ADDENDUM NO. 3

**RE: NCDAC NC Correctional Institution for Women
Air Conditioning Installation
SCO ID#: 22-24913-02A
NCDAC Central Engineering Job Order # 4290**

DATE: September 12, 2023

2 AHU CONTROL SCHEMATIC (FOR AUDITORIUM)

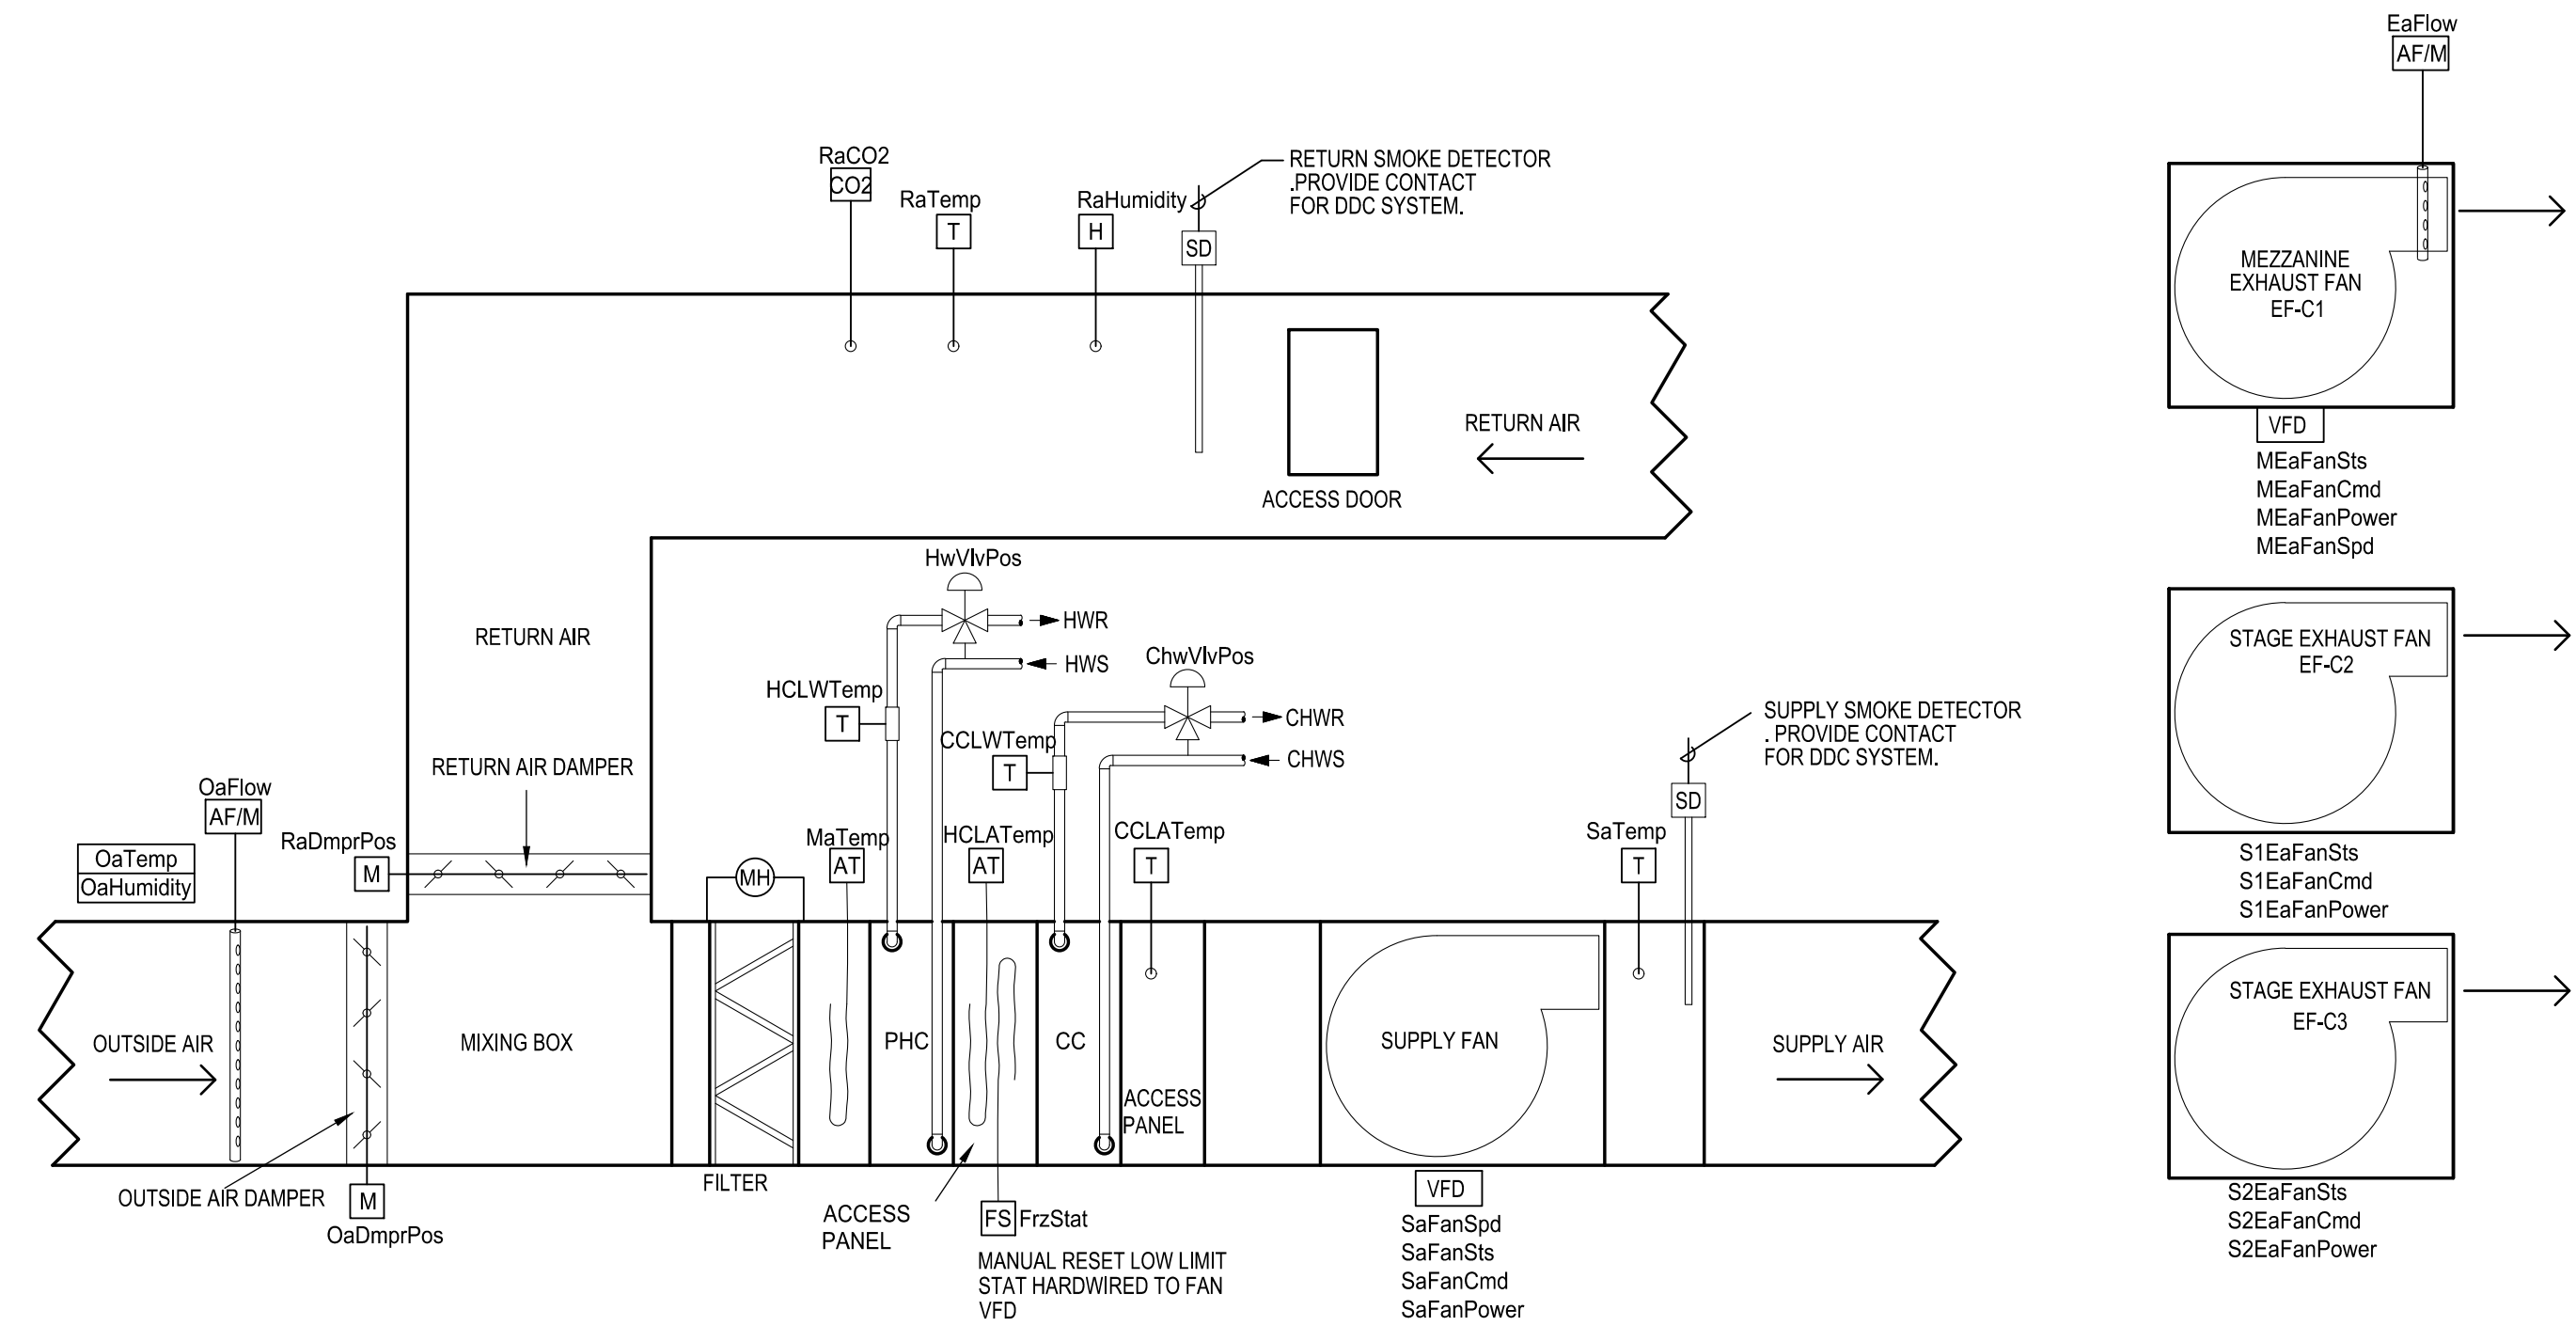
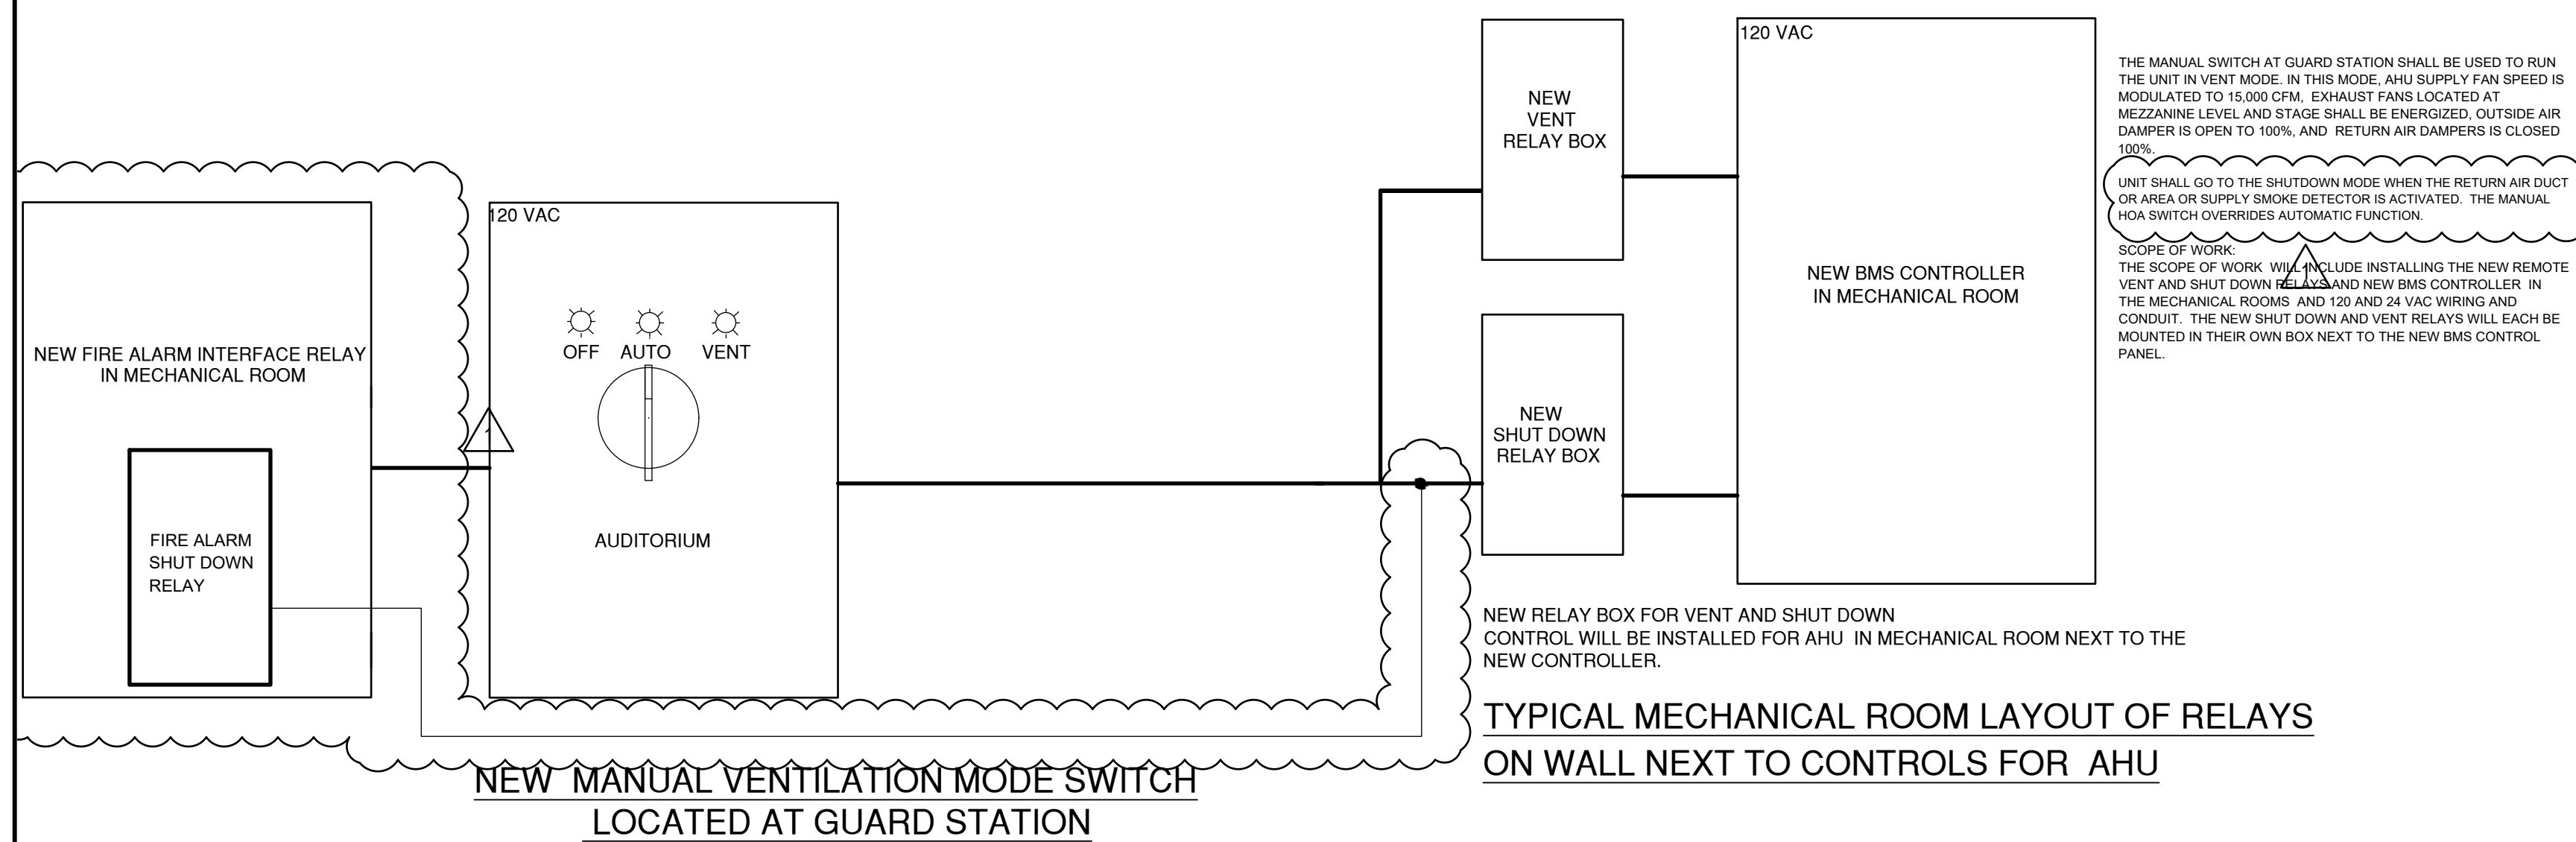
12. Sheet M603: Revise sequence of operation. See revisions on attached sheet.
13. Sheet M604: Revise sequence of operation. See revisions on attached sheet.

- UNOCCUPIED MODE: OA DAMPERS TO REMAIN FULLY CLOSED. SUPPLY AIR FAN SHALL CYCLE ON WHEN THERE IS A CALL FOR HEATING. OTHERWISE THE FAN IS TO REMAIN OFF.

- WARMUP: OA DAMPERS REMAIN FULLY CLOSED. THE MORNING WARM UP PERIODS SHALL BE OPTIMIZED DEPENDING ON THE OUTDOOR AND INDOOR AIR CONDITIONS.
- COOLDOWN: OA DAMPERS REMAIN FULLY CLOSED EXCEPT WHEN ECONOMIZING. THE MORNING COOLDOWN PERIODS SHALL BE OPTIMIZED DEPENDING ON THE OUTDOOR AND INDOOR AIR CONDITIONS.

- COOLING/HEATING MODE: THERE ARE TO BE SEPARATE HEATING AND COOLING TEMPERATURE SET POINTS FOR THE SPACE. INITIAL SPACE TEMPERATURE SET POINTS ARE 70°F HEATING AND 75°F COOLING WITH A 2 DEGREE ADJUSTMENT ON THE DIAL. IF THE SPACE IS ABOVE COOLING SET POINT THE DISCHARGE AIR TEMPERATURE SET POINT IS TO BE 55°F. IF THE SPACE IS BELOW HEATING SET POINT THE DISCHARGE AIR TEMPERATURE IS TO BE 110°F. IF THE SPACE IS AT OR BETWEEN COOLING AND HEATING TEMPERATURE SET POINTS THE DISCHARGE AIR TEMPERATURE SET POINT IS TO BE DETERMINED BASED ON A PID LOOP WITH A MINIMUM OF 55°F AND A MAXIMUM OF 110°F. THE PID LOOP SHOULD BE WRITTEN SUCH THAT WHEN THE SPACE TEMPERATURE IS 0.5°F OR MORE BELOW THE COOLING SET POINT THE COOLING VALVE IS CLOSED. SIMILARLY, WHEN THE SPACE TEMPERATURE IS 0.5°F OR MORE ABOVE THE HEATING SET POINT THE HEATING VALVE SHOULD BE CLOSED.

- ECONOMIZING: WHEN THE OUTDOOR AIR ENTHALPY IS LOWER THAN 28 BTU/LB AND THE OUTDOOR AIR TEMPERATURE IS LOWER THAN (75 °F), SUPPLY FAN SPEED SHALL MODULATE DOWN TO 15,000 CFM. THE OUTSIDE AIR DAMPER IS OPEN TO 100%. RETURN AIR DAMPER IS CLOSED; EXISTING EXHAUST FANS LOCATED AT MEZZANINE LEVEL AND STAGE SHALL RUN AT MAXIMUM AIR FLOW. IF SUFFICIENT FREE COOLING IS NOT AVAILABLE, CHILLED WATER COIL SHALL BE USED TO SUPPLEMENT THE COOLING. OA TEMPERATURE AND HUMIDITY ARE TO BE FROM THE GLOBAL DDC SENSORS.
CHW OPTIMIZATION WHEN ECONOMIZING: WHEN ECONOMIZING CONTROL OF THE CHW VALVE SHALL BE INITIALLY OVERRIDDEN TO STAY CLOSED, ALLOWING THE FAN TO SPEED UP AS NECESSARY TO MEET THE LOAD. ONCE THE FAN REACHES 15,000 CFM THE CHW VALVE OVERRIDE WILL BE DISCONTINUED AND NORMAL CHW VALVE CONTROL WILL RESUME.

- DEMAND CONTROL VENTILATION: VENTILATION RATE SET POINT SHALL BE BASED ON RETURN AIR CO₂ SENSOR. VENTILATION SHALL BE REDUCED WHEN RETURN AIR CO₂ LEVELS ARE BELOW THE ESTABLISHED THRESHOLD (1000 PPM). A MINIMUM ALLOWABLE VENTILATION RATE SHALL BE ESTABLISHED BASED ON THE MINIMUM REQUIRED TO MEET LOW- OR NO-OCCUPANCY VENTILATION REQUIREMENTS OR MAKEUP AIR REQUIREMENTS, WHICHEVER IS GREATER. THE MAXIMUM ALLOWABLE VENTILATION RATE SHALL BE EQUAL TO THE SCHEDULED DESIGN VENTILATION RATE. IN THIS MODE OUTSIDE AIR FLOW SENSOR AND MEZZANINE LEVEL EXHAUST FAN AIR FLOW SENSOR TRACK TOGETHER AND MODULATE THE SPEED OF EXHAUST FAN TO MEET THE VENTILATION DEMAND.

- DELAYED VENTILATION: WHEN TRANSITIONING FROM WARMUP OR COOLDOWN MODE TO OCCUPIED MODE, VENTILATION RATE SET POINT SHALL INITIALLY BE (X)% OF THE MINIMUM ALLOWABLE VENTILATION RATE. AFTER (X) HOURS INCREASE VENTILATION RATE SET POINT TO THE MINIMUM ALLOWABLE VENTILATION RATE.

- FREEZE PROTECTION: IN NORMAL MODE OF OPERATION, LOW LIMIT CONTROLLER WITH SENSOR (FREEZE STAT) LOCATED DOWNSTREAM OF THE DUCT REHEAT COIL SHALL DE-ENERGIZE THE SUPPLY FAN AND CLOSE THE OUTDOOR AIR DAMPERS IF THE TEMPERATURE FALLS BELOW 40°F. IN ADDITION, THE HOT AND CHILLED WATER CONTROL VALVE ACTUATORS SHALL BE DE-ENERGIZED AND THE VALVES WILL SPRING RETURN TO THE OPEN POSITION. DE-ENERGIZING SHALL BE ACCOMPLISHED VIA DDC SYSTEM. IN VENT MODE, WHEN AMBIENT TEMPERATURE IS LOWER THAN 40°F, FREEZE STAT IS BYPASSED AND ENERGIZE THE SUPPLY FAN TO REMOVE TEAR OR MACE GAS FROM THE BUILDING.

- SMOKE SHUTDOWN/MANUAL VENTILATION MODE: ACTIVATION OF THE RETURN AIR OR OR AREA OR SUPPLY SMOKE DETECTOR SHALL DE-ENERGIZE THE SUPPLY FAN AND RETURN TO THE OPEN POSITION. THE SMOKE DETECTOR SHALL CONTACT THE DDC SYSTEM FOR INFORMATIONAL PURPOSES.
THE MANUAL SWITCH AT GUARD STATION SHALL BE USED TO RUN THE UNIT IN VENT MODE. IN THIS MODE, AHU SUPPLY FAN IS MODULATED TO 15,000 CFM. EXHAUST FANS LOCATED AT MEZZANINE LEVEL AND STAGE SHALL BE ENERGIZED. OUTSIDE AIR DAMPER IS OPEN TO 100% AND RETURN AIR DAMPER IS CLOSED. HOT WATER VALVE SHALL OPEN 100% IF OUTSIDE TEMPERATURE IS BELOW 45 DEGREES. IF OUTSIDE TEMPERATURE IS ABOVE 45 DEGREES CONTROL VALVE REMAINS CLOSED. THE CHILLED WATER COIL CONTROL VALVE ALSO REMAINS CLOSED IN THIS MODE.
